# UNITED STATES PATENT AND TRADEMARK OFFICE

10/562,681

<b>Office Action Summary</b>	<b>Application No.</b> 10/562,681	<b>Applicant(s)</b> ANDOH ET AL.	
	<b>Examiner</b> DAVID C. MELLON	<b>Art Unit</b> 1797

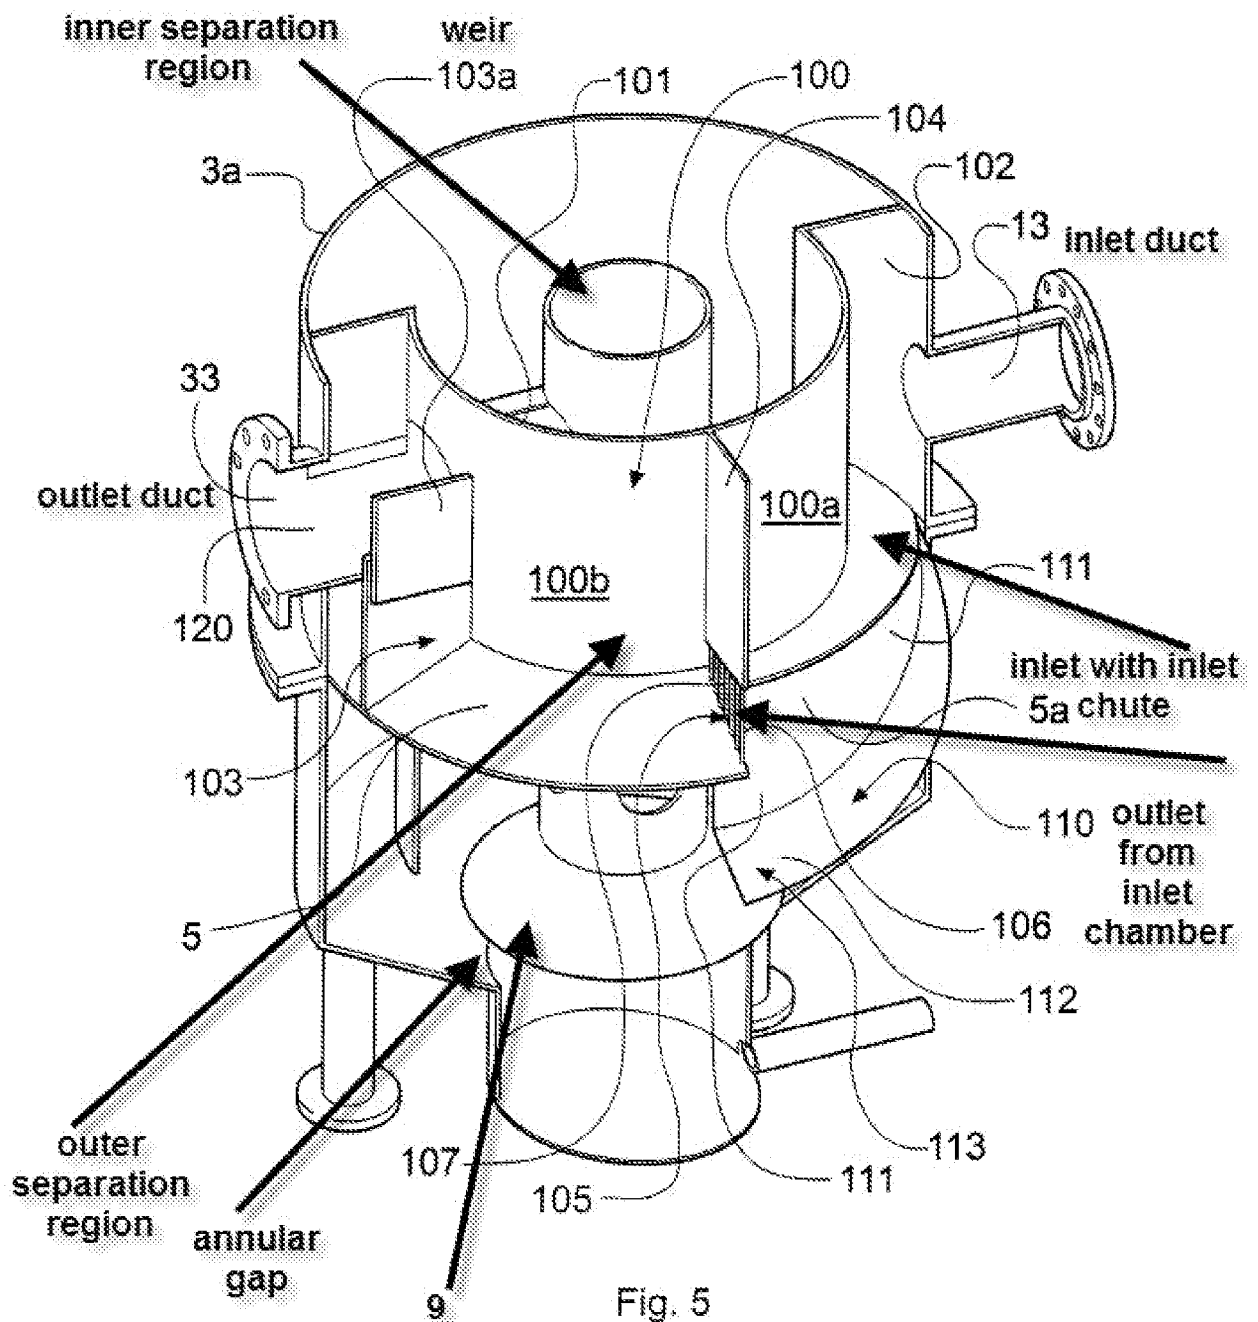
- An inner partition (chamber – 31)
- An inlet (13) opening into the outer separation region (see annotated figure 5)
- An outlet (33) opening into the inner separation region (see annotated figure 5)
- A frustoconical base (4) which converges to a downward outlet opening (8) which outlet opening (8a) communicates with the outer separation region beneath the inner partition (clearly shown in fluid communication)
- Wherein the inner separation region is annular (it is round and thus annular) and is closed at a lower end thereof (P12/L18-22 - "the conical member 9 may be solid" which would imply that it would close a portion of all of a lower end of the inner separation region).

Regarding claim 12, Andoh et al. further discloses that the wall (9) terminates short of the frustoconical base of the vessel, creating a gap between the base and the wall (see annotated figure 5).

inlet duct which extends through the outer wall (see annotated figure 5, inlet and outlet 13 and 33 extending through vessel wall and inline with one another).

Regarding claim 18, Andoh et al. further discloses an inlet disposed below the inlet duct (see annotated figure 5) with an inlet port to discharge inlet flow into the vessel in a tangential direction to the cylindrical outer wall (inlet chute is wrapped around the cylindrical wall).

Regarding claims 23 and 24, Andoh et al. further discloses that the inner partition (31) is cylindrical (shown in annotated figure 5) and that the inner partition is coaxial with the outer wall (see figure 4).
